GRO ARCHITECTS, PLLC

PROJECT: **803 S URBAN RENEWAL LLC**  
 BLOCK 645, LOT 12  
 PROPOSED MIXED USE BUILDING  
 CITY OF PLAINFIELD, UNION COUNTY, NEW JERSEY

# DESIGN KEY POINTS- SUMMARY OF UPDATES

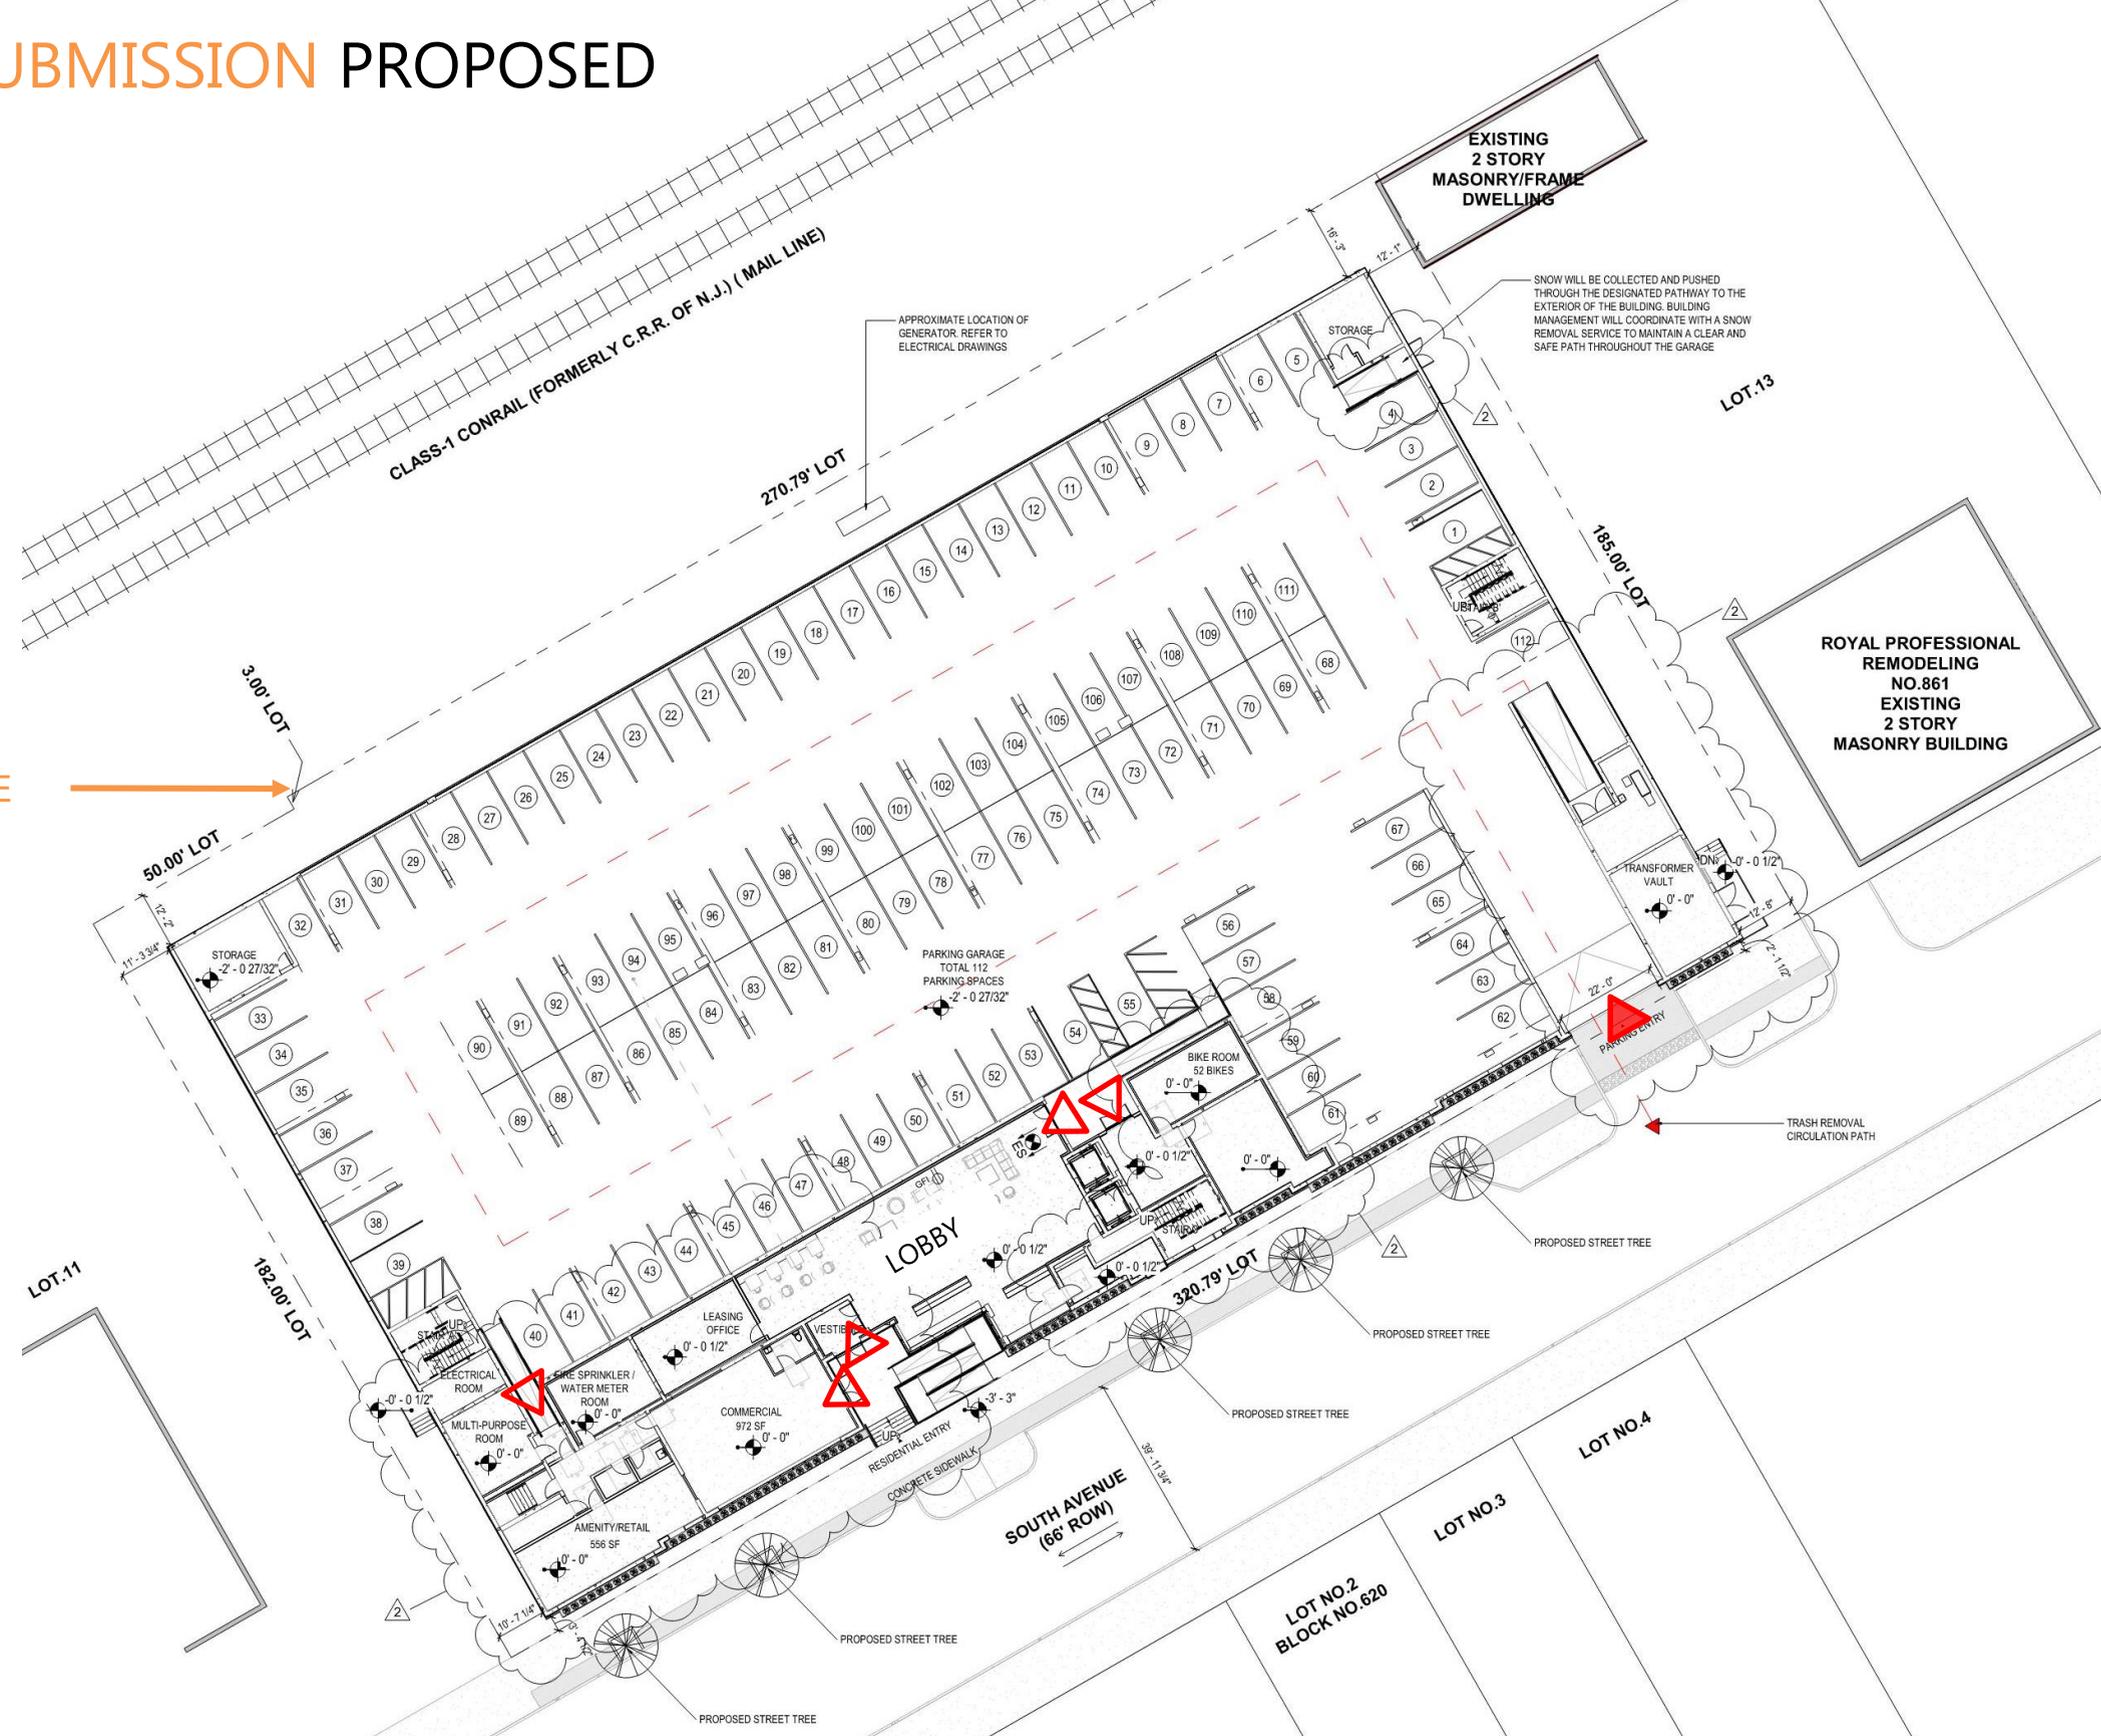
- 104 UNITS TOTAL
  - STUDIO: 10
  - 1 BEDROOM: 61
  - 2 BEDROOM: 33
- 112 PARKING SPACES
- PARKING ENTRANCE WIDTH: 24'-0"
- 8' X 8' TRANSFORMER PAD
- 2 STAIRS FOR EGRESS FOR ENTIRE BUILDING
- 885 SF COMMERCIAL SPACE
- MAINTENANCE SHOP 18' X24'

- 104 UNITS TOTAL
  - STUDIO: **7 – SEE TYPE D**
  - 1 BEDROOM: **60**
  - 2 BEDROOM: 37
- 112 PARKING SPACES
- PARKING ENTRANCE WIDTH: 22'-0"
- TRANSFORMER VAULT PER PSEG REQUIREMENTS
- 3 STAIRS FOR EGRESS FROM 2<sup>ND</sup> FLOOR, 2 REMAIN FOR REST OF BUILDING
- 972 SF COMMERCIAL SPACE WITH ADA COMPLIANT RESTROOM
- 556 SF OF ADDITIONAL COMMERCIAL/RETAIL SPACE

## TYPICAL UNIT- WORKSPACE TYPE 1

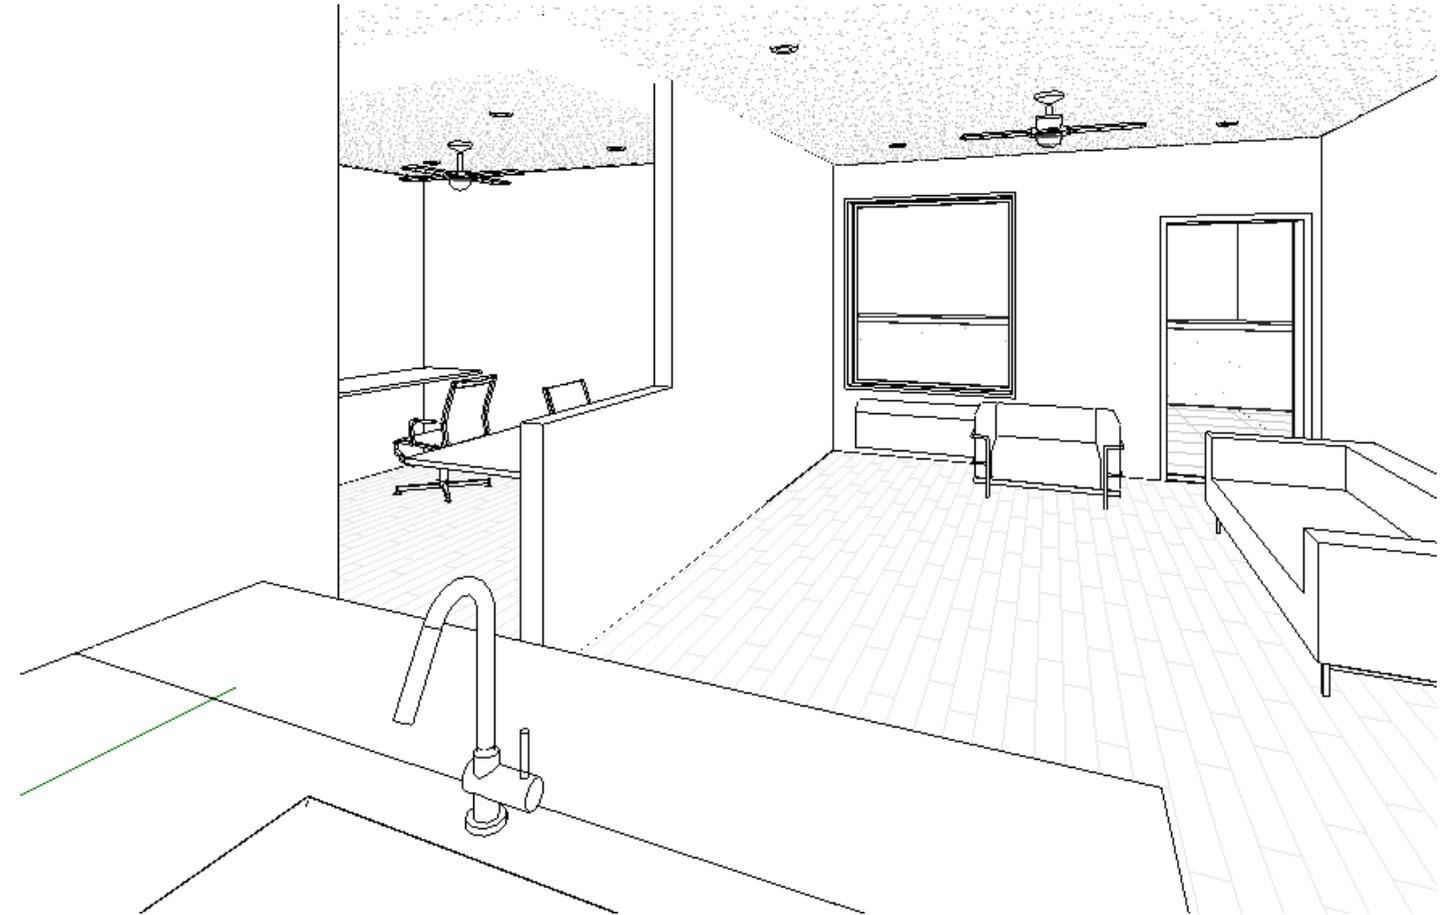
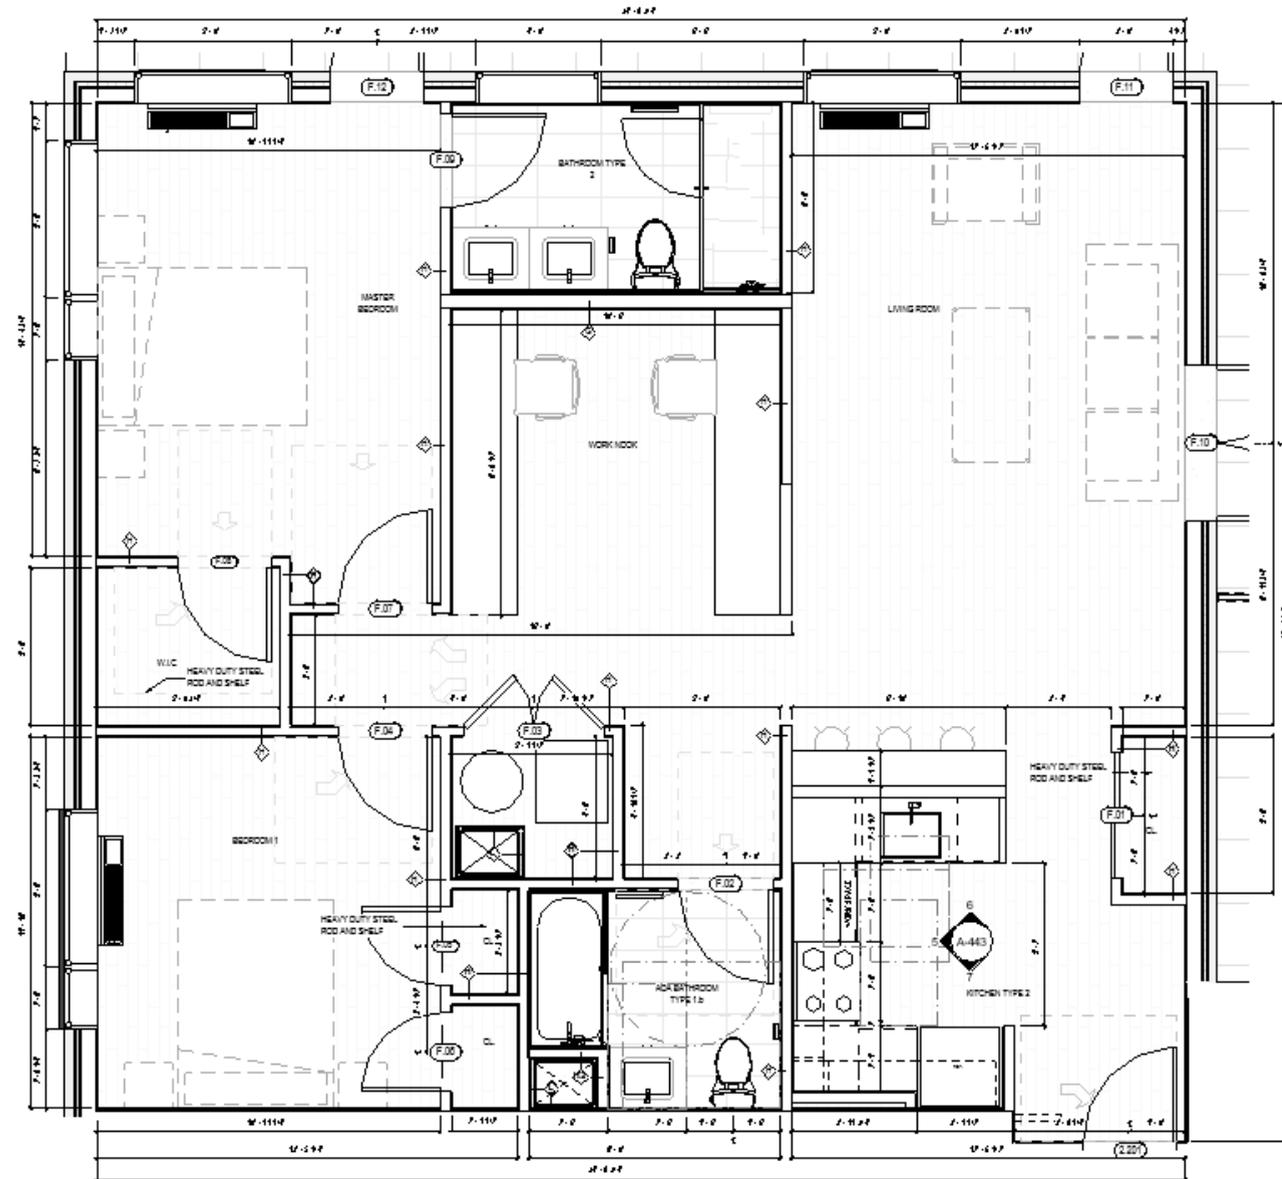
UNIT TYPE F  
'L' SHAPED HALF WALL

## TYPICAL UNIT- WORKSPACE TYPE 2

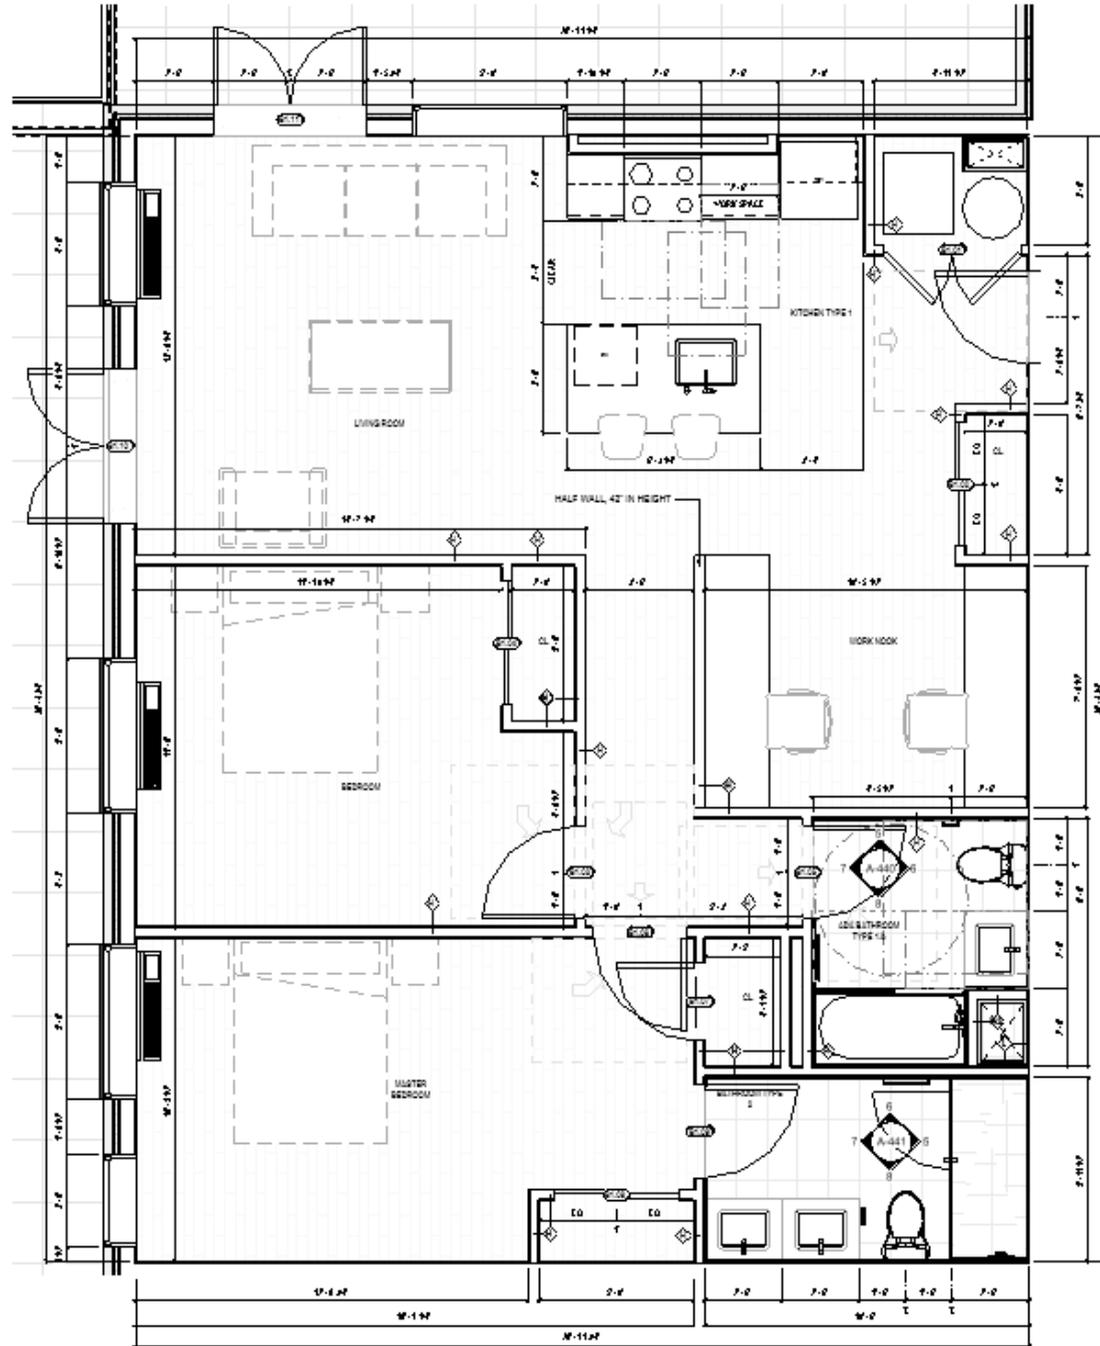
UNIT TYPE B  
42" HALF WALL

## TYPICAL UNIT- WORKSPACE TYPE 3

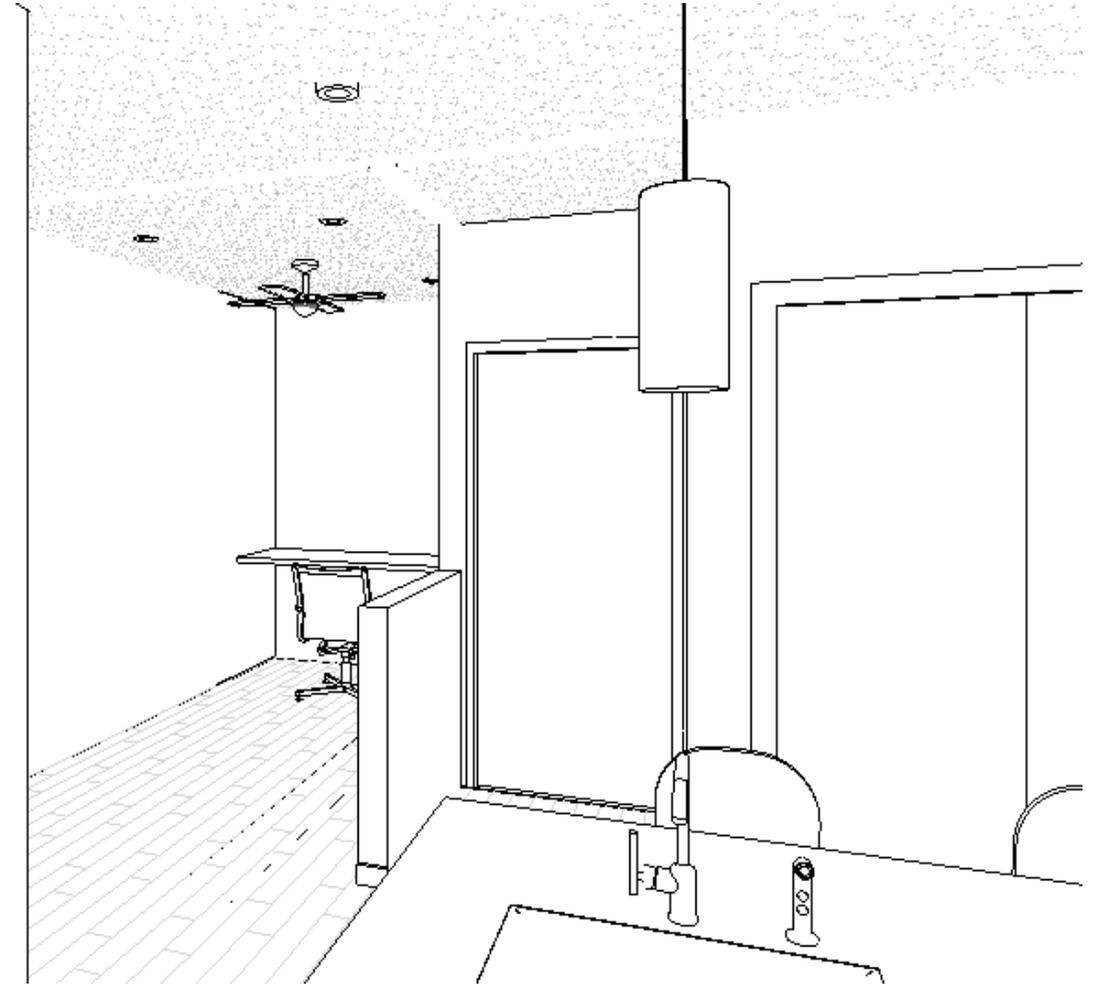
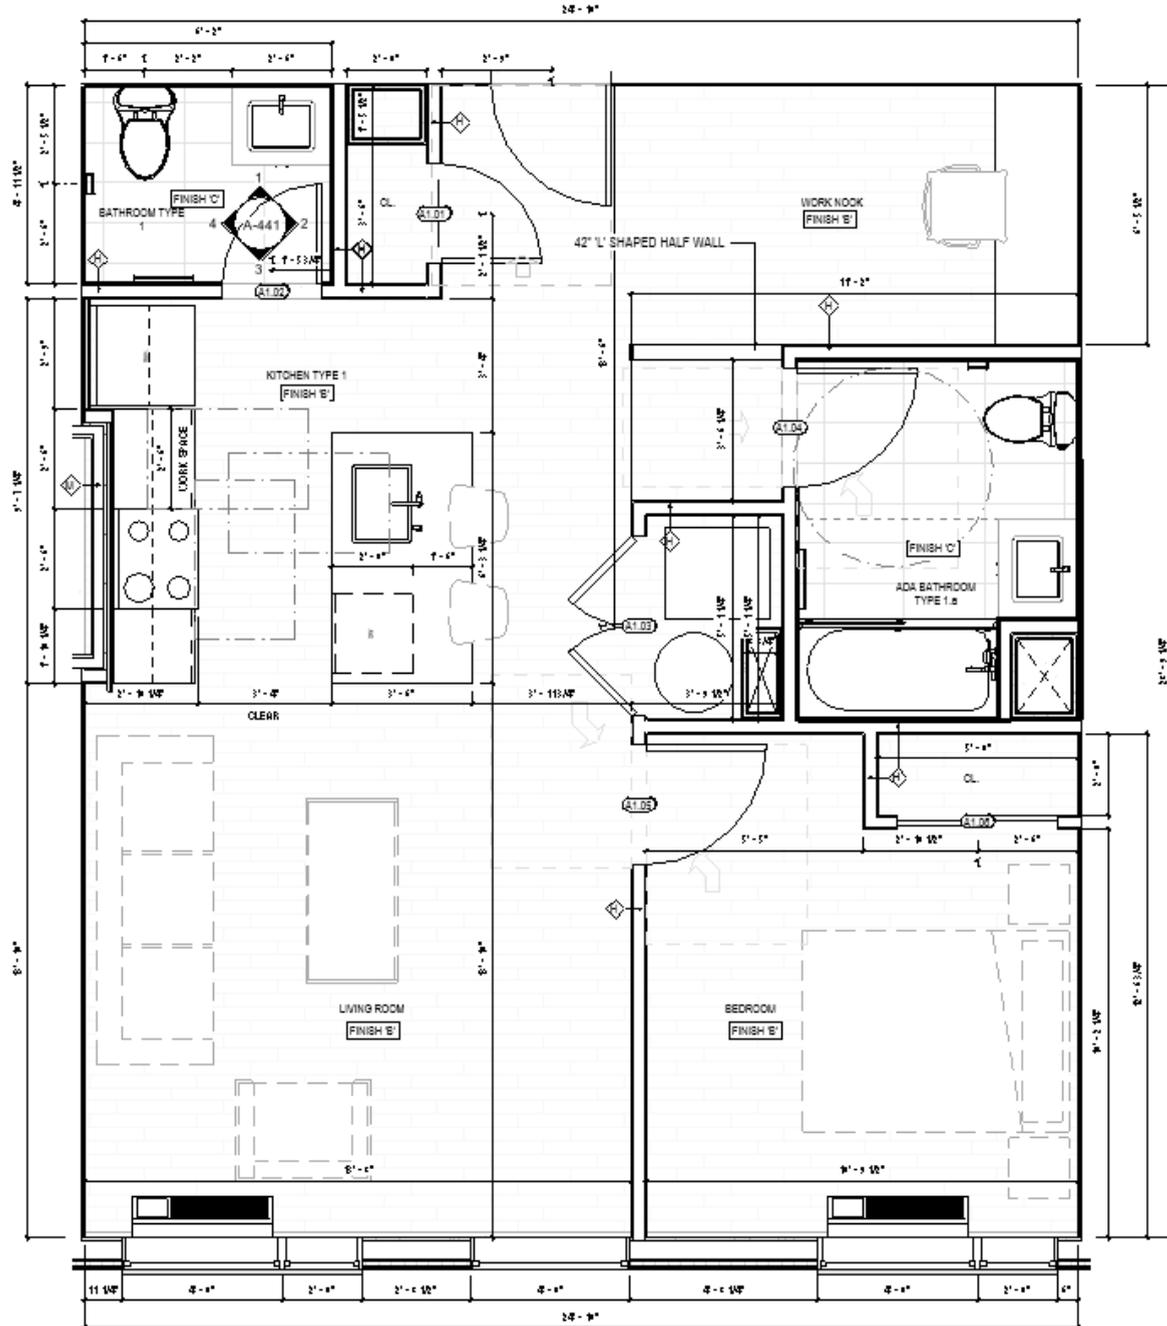
UNIT TYPE A  
REMOVAL OF WALL & 'L' SHAPED HALF WALL
